**Cumberland County
Subdivision and Land Development
Review Report**

Municipality:	Date Received:	Date Reviewed:	Reviewed By:	Plan Number:
Lemoyne Borough	8/17/2022	9/1/2022	SH	22-111
<i>Plan Title:</i>				
<i>Taco Bell</i>				
Plan Status:	<i>Plan Type:</i>			<i>Land Development Plan</i>
<i>Comments and Recommendations:</i>

SITE PLAN

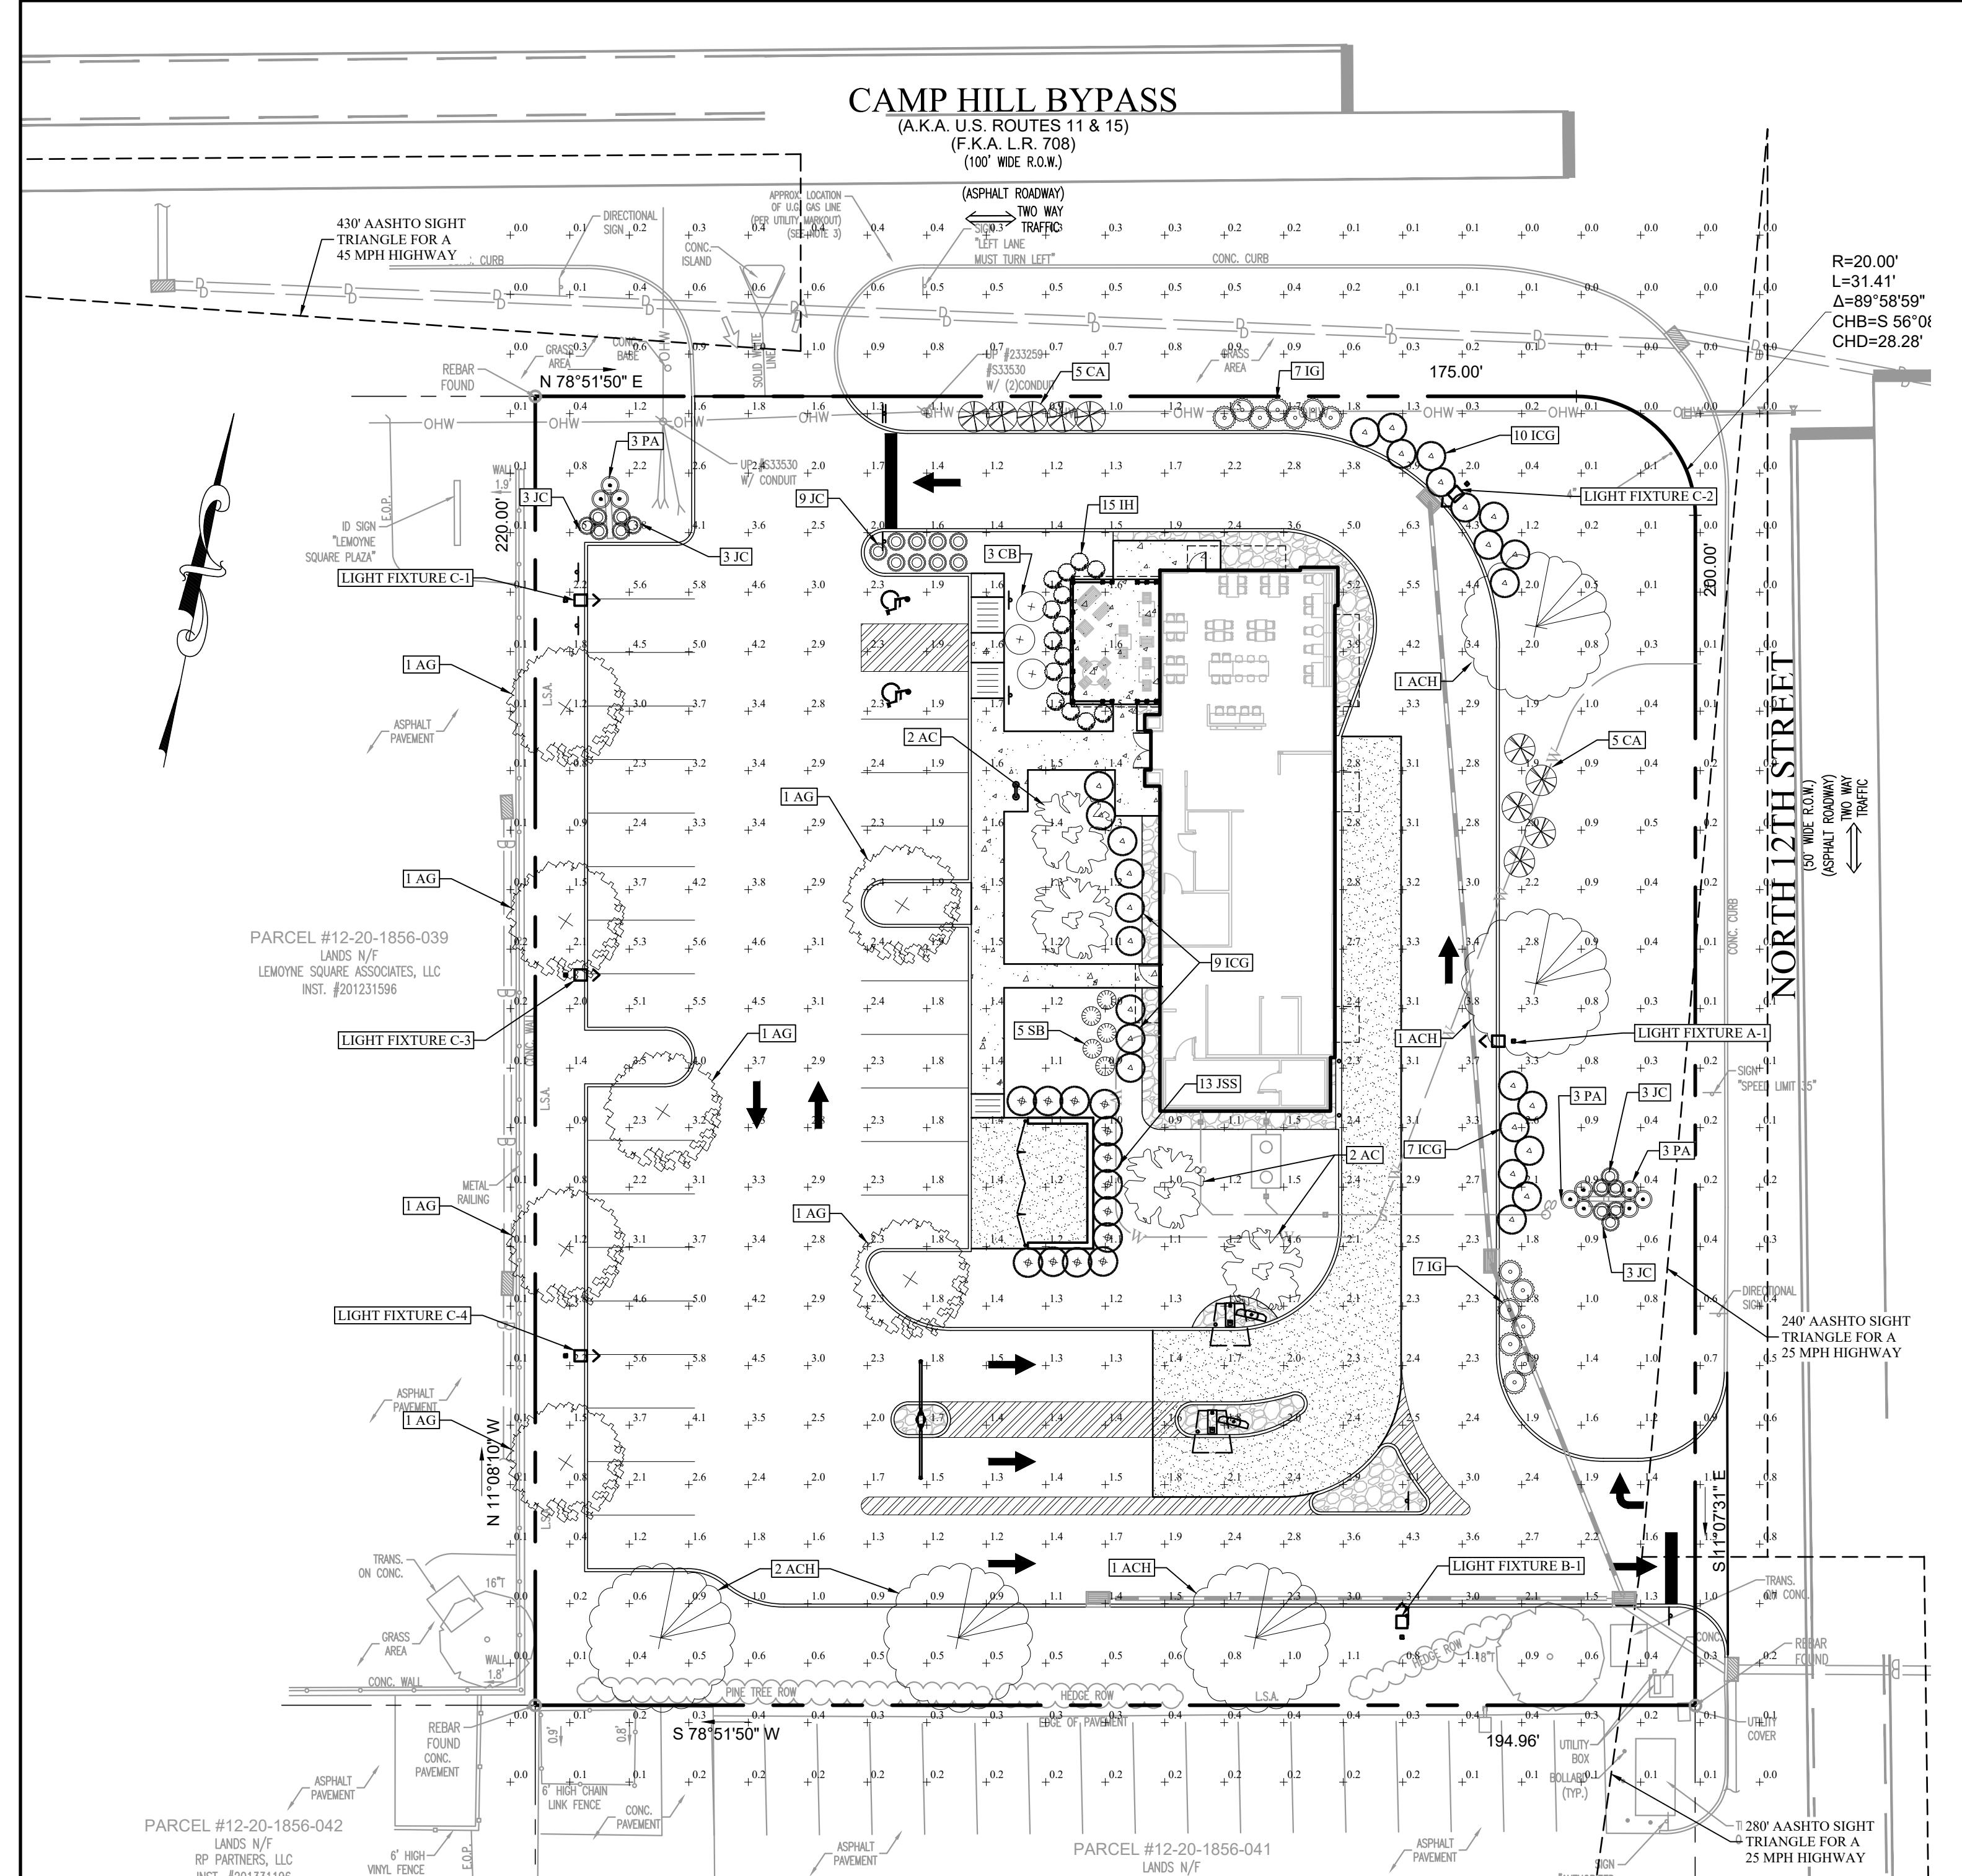
1. All applicable zoning overlay districts should be included in the zoning schedule on sheet 3 (zoning 550-6.A).
2. It appears that the trash enclosure is located behind the parking stalls. The applicant should verify that the garbage haulers will be able to access the dumpster for trash collection (zoning 550-35.A and 550-45.C).

4. The applicant should review the landscaping and lighting plan. The west side of the parking lot proposes a tree in a parking space (zoning 550-67.B.2.A.5).

6. Trash receptacles should be provided in the patio area (zoning 550-88.G.3.H).
7. The plan should include separate blocks for variances (from zoning) and waiver requests (from SLDO). The variances block listed on sheet 3 include several waiver requests (SLDO 480-9.A.2.C).

15. The caliper size of each proposed deciduous tree should be provided on the landscaping and lighting plan (SLDO 480-33.C.1).
16. A minimum of 2 planting units is required for every 1,000 square feet of building coverage. The cover sheet and/or the landscaping plan should include proof of compliance (SLDO 480-33.E.3.A.2).
